GAMMA RAY OBSERVATORY NICKEL-CADMIUM BATTERY EVALUATION

NORMAN R. SCHULZE

MARCH 19, 1989

The NASA Aerospace Flight Battery Systems Steering Committee, during the 10th Committee meeting on February 7, 1989, reviewed the status of GRO's battery and cell (Gates) problems to assist the GRO Program Office with a risk assessment of those nickel-cadmium cells.

Figure 1. Performance comparison of Packs 6051A (Lot 16) and 6051B (Lot 17) by cell number, as a function of test cycles.

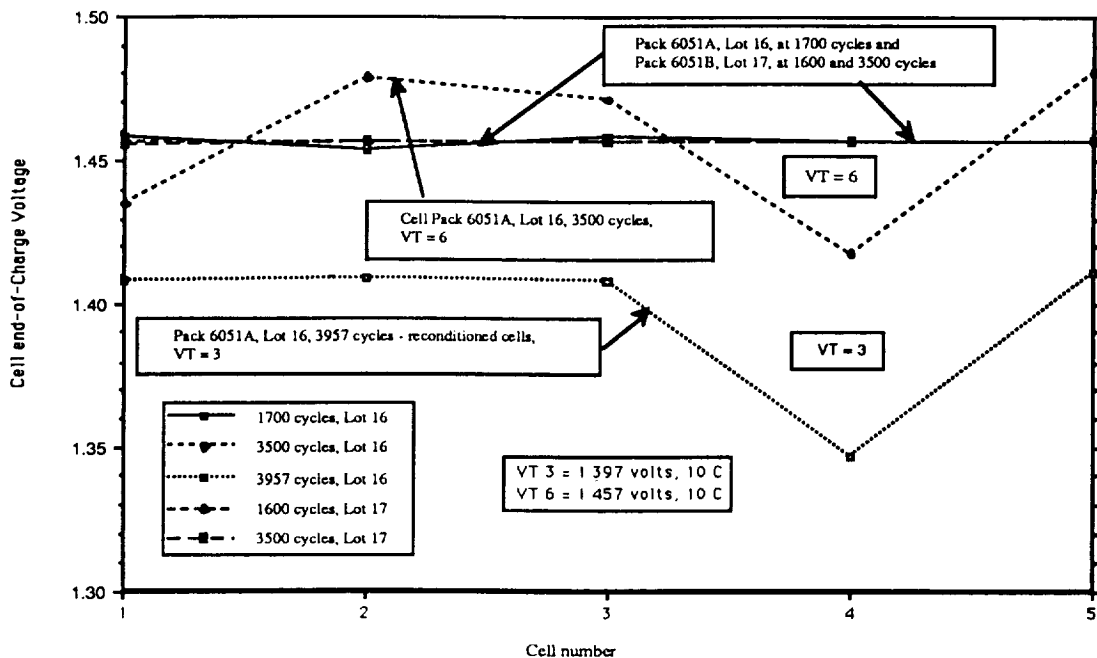
The figure shows discrepant behavior between cells number one and four from the other cells in pack number 6051A. Instrumentation accuracy is $\pm 0.05\%$. As a figure of merit, a plot of the good Lot 17 pack number 6051B cells is included to illustrate their performance characteristics at 1600 and 3500 cycles, basically a flat curve with a one sigma deviation of 1.6 mv at 3500 cycles. Observe, too, that the performance of the Lot 16 cells at 1700 cycles matches identically with the Lot 17 cells at 1600 and 3500 cycles. That is the performance level expected from properly performing cells.

Notice that the 3 good cells in Lot 16 shifted higher than Lot 17 at 3500 cycles. This is attributed to the VT control system raising the voltage level of the good cells to compensate for the voltage degradation of the malfunctioning cells. This stresses the good cells by operating them at a higher voltage while degrading the low voltage cells. The average pack voltage is maintained at the required level of 1.457 volts. This shows the importance of cell matching.

At 3500 cycles cell number 4 was observed at 1.418 volts at the end of charge while operating at the VT 6 charging level. The cells were removed from test (3512 cycles) and a capacity check made on all five cells. A diverging capacity was the result. Because the cells had been allowed to stand open circuited for 5 weeks, from November 7 to December 14, 1988, when the capacity of each cell was checked, some question was raised over the validity of the results. The data are presented in Table 1:

Figure 2. GRO, Lot 16, cell numbers 1 and 4 voltage degradation as a function of life cycles.

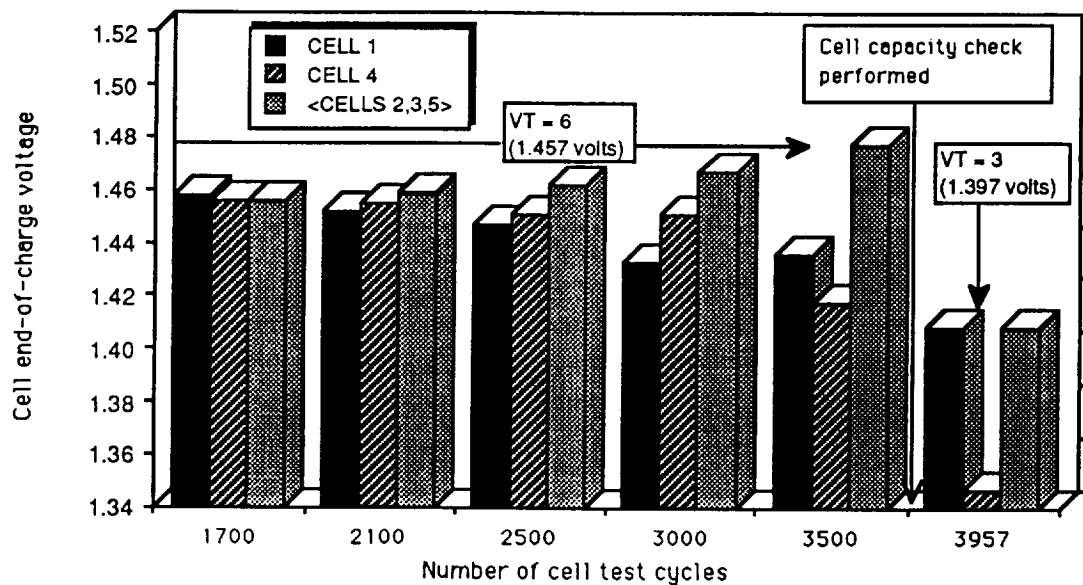
- At 1700 cycles, Figure 2 shows consistent performance among the 5 cells.
- As cell 1's voltage decreases at 2100 cycles, the charging circuit increases the voltage of cells 2, 3, and 5 to maintain the average pack voltage for VT = 6. Cell 4 diverges from operating at the higher voltage level of cells 2, 3, and 5.
- At 2500 cycles, the cell 4 voltage decreases below its 1700 cycle value, and cell 1 descends further. Meanwhile, the mean Σ 2, 3, 5 cell voltage rises higher to compensate for the divergence.
- At 3000 cycles, a further decrease occurs in cell 1's voltage and cell 4's voltage remains unchanged. Cells 2, 3, and 5 rise higher.
- At 3500 cycles, cell 4's voltage rapidly descends, and cell 1 commences to ascend, perhaps in response to the low voltage of cell 4. The mean Σ 2, 3, 5 cell voltages increases further to maintain the VT = 6 pack voltage control level. The individual

values for cells 2, 3, 5 were not plotted since they were matched closely within a one sigma value of 3.7 mv.

- At 3512 cycles, the Pack 6051A was removed from testing, its cells' capacities checked, cells reconditioned, and returned to test.
- At 3989 cycles, cell 4 degraded further, and the was cell removed on February 2, 1989 from further testing in the pack. Notice that at the VT = 3 level, cell 1 is now being controlled to operate at a lower voltage level than the voltage to which it had previously degraded. Pack 6051 A was returned to test after cell removal and cycled for 62 cycles at VT = 3, then incrementally increased to VT = 4 (+68 cycles), 5 (+62 cycles), 6 (+61 cycles, February 21, 1989). Cell 1 has maintained a voltage level consistent with cells 2, 3, 5, the difference between those 4 cells being 2 mv.

The cells' performance characteristics in Pack 6051A, however, have now been altered by the procedure which called for the cell capacity to be checked following cycle number 3512. Whenever cells are taken off test for a capacity check, the cells are deep discharged. That is a procedure which, in effect, reconditions the cell; but it is a procedure which cannot be accomplished in flight. Hence, the performance and electrical characteristics of any cell subjected to a capacity check during a pack test can differ from flight cells where the reconditioning circuitry is not available.

Two points are important concerning the above sequence as an indicator of Lot 16's performance. First, no means exists to establish the effect of the three reconditionings of cell 1 after cycle 3512. It is important to point out that the test pack's electrochemical characteristics have been altered (improved) and that no similar cell reconditioning capability exists in orbit. The results of the pack testing from here on can be misleading, in an optimistic perspective, since reconditioning tends to temporarily improve cell performance. Second, a good quality, commercial grade nickel-cadmium cell will exhibit a 7% capacity loss per month at the 10 °C temperature in this test (Lin). Cells 2 and 5 lost 10 and 9% respectively in 5 weeks, indicating nominal performance. Cell 3 was higher at 21%.

There was a question whether the electrochemical condition of cell number 4 was exacerbated by the divergence being allowed to continue in test in the October-November time frame without receiving more prompt attention to VT adjustments. Some of the members were of the opinion that some degree of cell voltage recovery may have been achieved or reduced voltage divergence had been possible with an earlier readjustment of the VT level.
